**ADDENDUM  
NO. 3**

**September 30, 2025**

**VALE FACILITY ADDITION/RENOVATIONS AND  
MAINTENANCE/IT FACILITY PROJECTS**

**Addendum Three (AD.03)** to the drawings and specifications prepared by Gibraltar Design for **Valparaiso Vale Facility Addition/Renovations and Maintenance/It Facility and Related Work** for Valparaiso Community Schools, Valparaiso, Indiana.

© GIBRALTAR DESIGN SHEET  
**S-404**

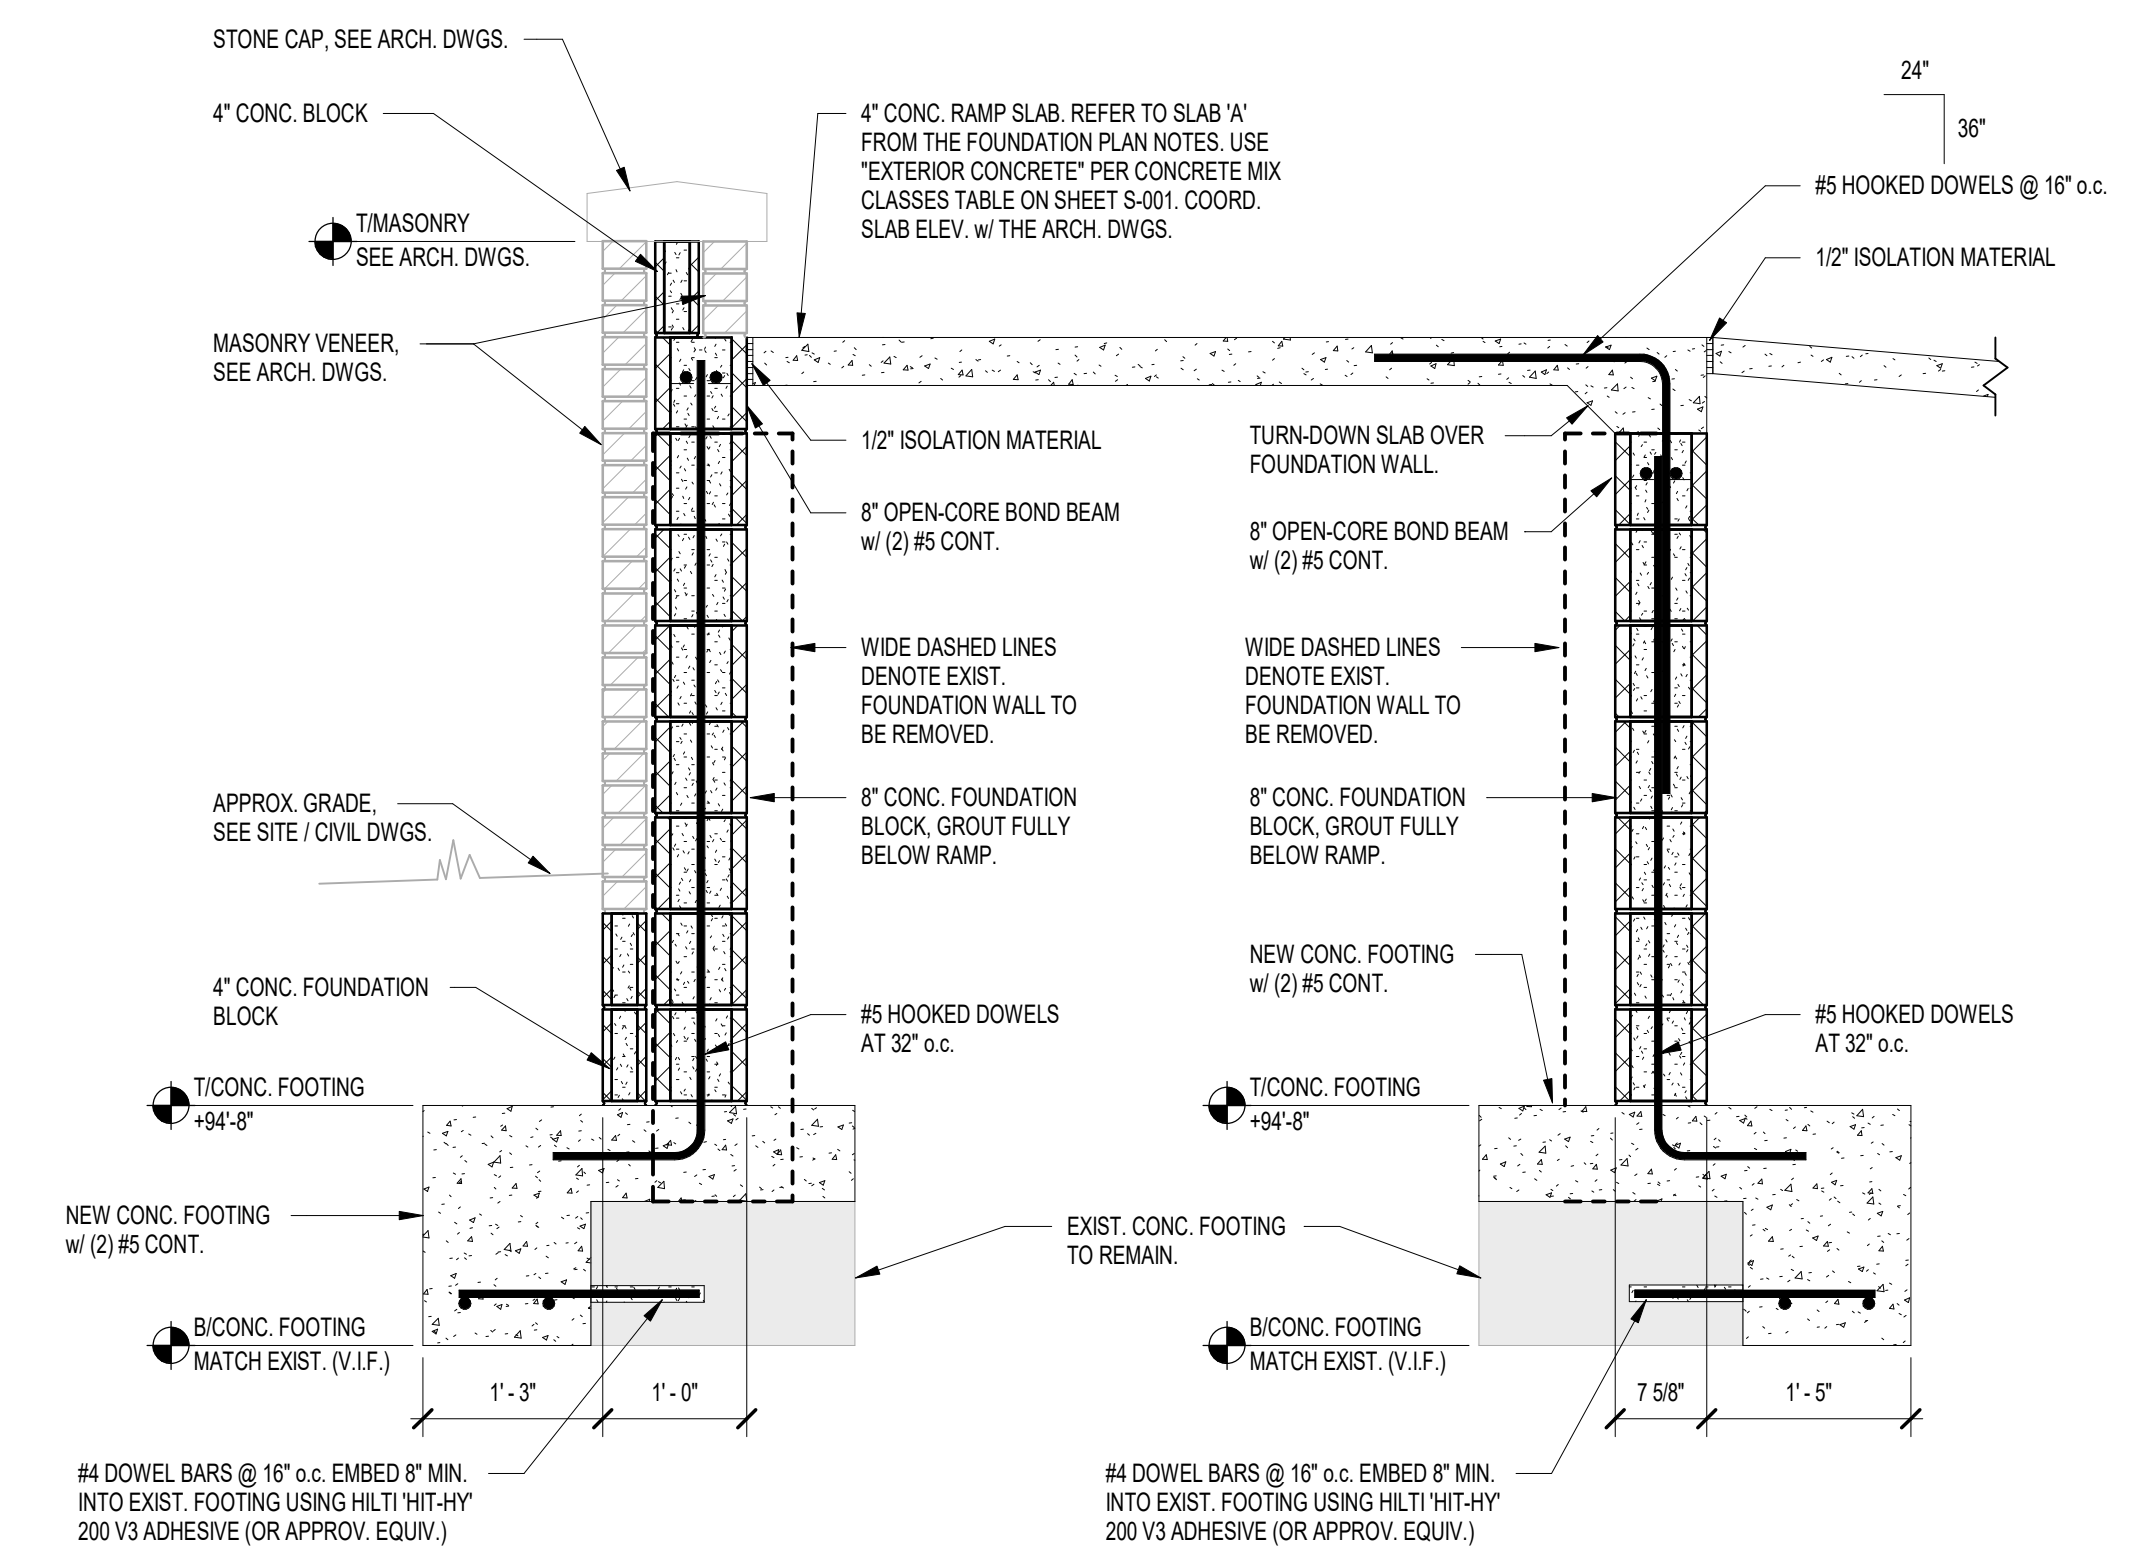
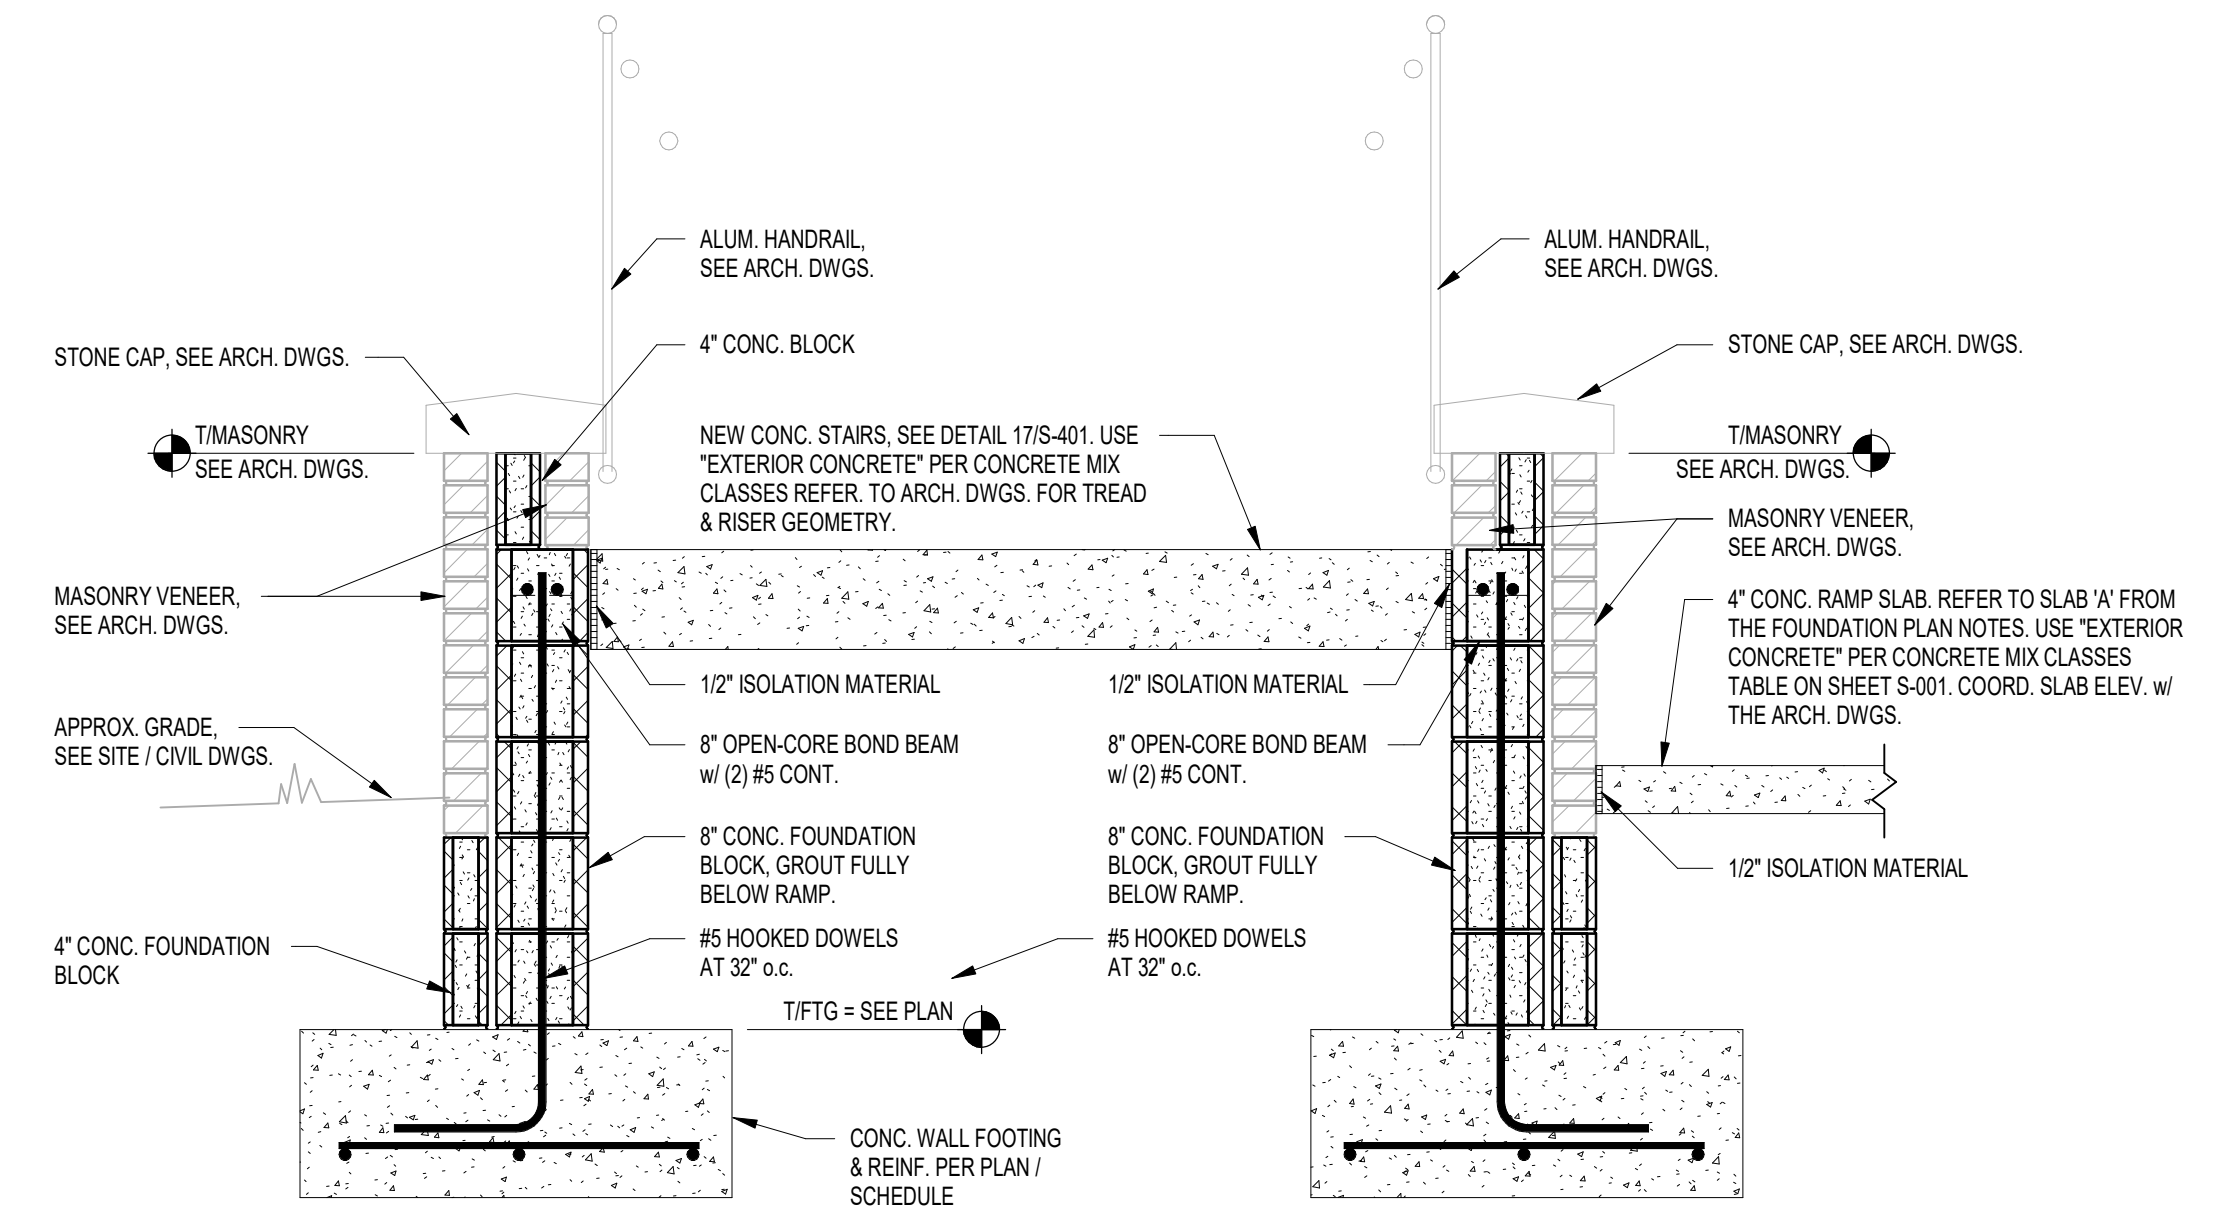
- A. Sheet S-404 has been added to the construction documents this Addendum.
